# BUILDING CODE OF AUSTRALIA COMPLIANCE REPORT (INCLUDING ACCESSIBILITY) NCC 2019 AMENDMENT 1

## 25 FRENCHS FOREST ROAD EAST, FRENCHS FOREST

Prepared for:	Australian Biotechnologies (John Seo) C/- Forma Projects (David Rinaldi)
Description:	Construction of a mezzanine with an enclosed room on top of the structure, at the rear of unit 4.
Report number:	220083r1
Date:	26.07.2022
Main contact:	David Rinaldi (Forma Projects) <a href="mailto:davidrinaldi@formaprojects.com.au">davidrinaldi@formaprojects.com.au</a>   0405 277 628
Report Author:	Adam Johannesen <a href="mailto:adam@buildinganatomy.com.au">adam@buildinganatomy.com.au</a>   0417 123 672
Peer Review:	Peter Antcliffe <a href="mailto:peter@buildinganatomy.com.au">peter@buildinganatomy.com.au</a>   0423 204 960

Fig.: 5.6.2: Unprotected metal pipe through fire wall (unit 5 to unit 6)

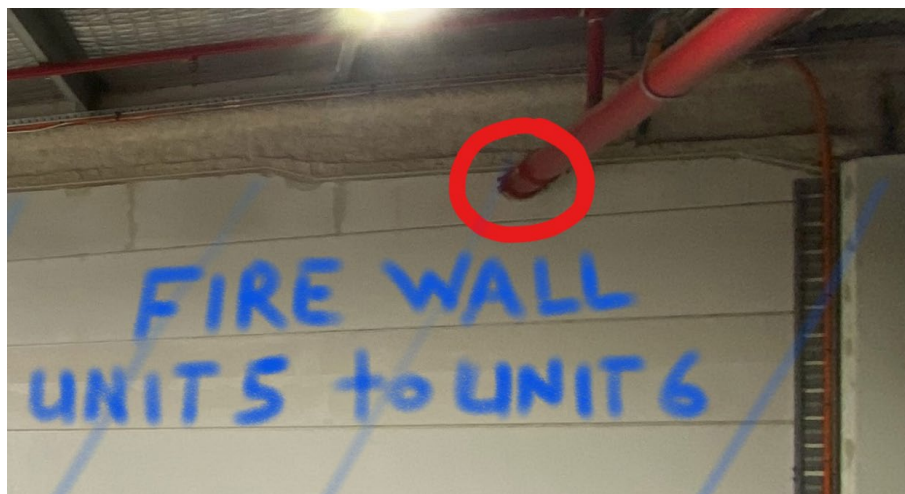
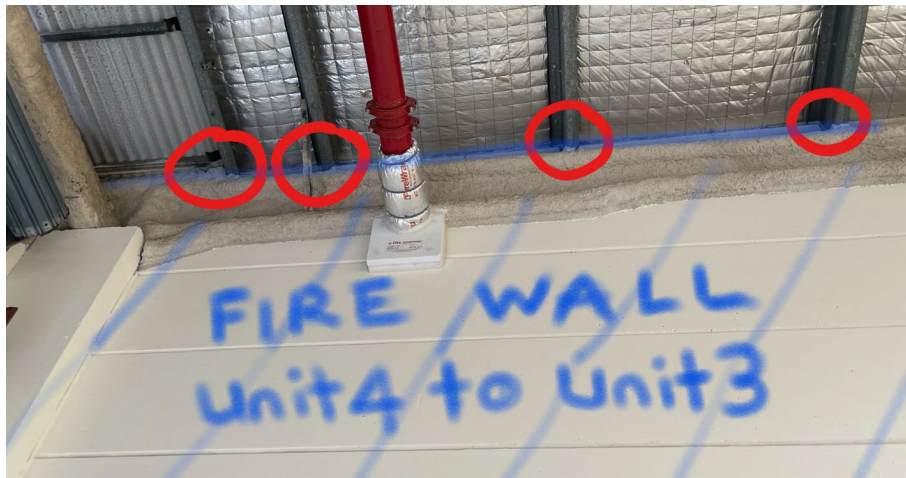
The existing fire walls that separate units 4 & 3, and units 5 & 6 incorporate metal purlins that appear to pass through the fire walls and also appear to be greater than 75mm x 50mm. In addition, there are unprotected penetrations through the fire wall between unit 5 a& 6. To ensure the validity of the assumptions and advice in this report, the fire walls must be confirmed **by a structural engineer** to comply with BCA

- C2.7(a)(iii): Building elements must not pass through or cross the fire walls unless the required fire resisting performance of the fire wall is maintained. Roof battens with dimensions 75mm x 50mm are permitted. In this regard, a **structural engineer** must confirm and certify that despite the purlins passing through the fire walls, the fire resistance performance of the fire walls is maintained. Where found to be deficient, remediation works are to be included in the development proposal.

*Fig.: 5.6.3:* Metal purlins appear to pass through the fire walls between units 4 & 3, and 5 & 6.
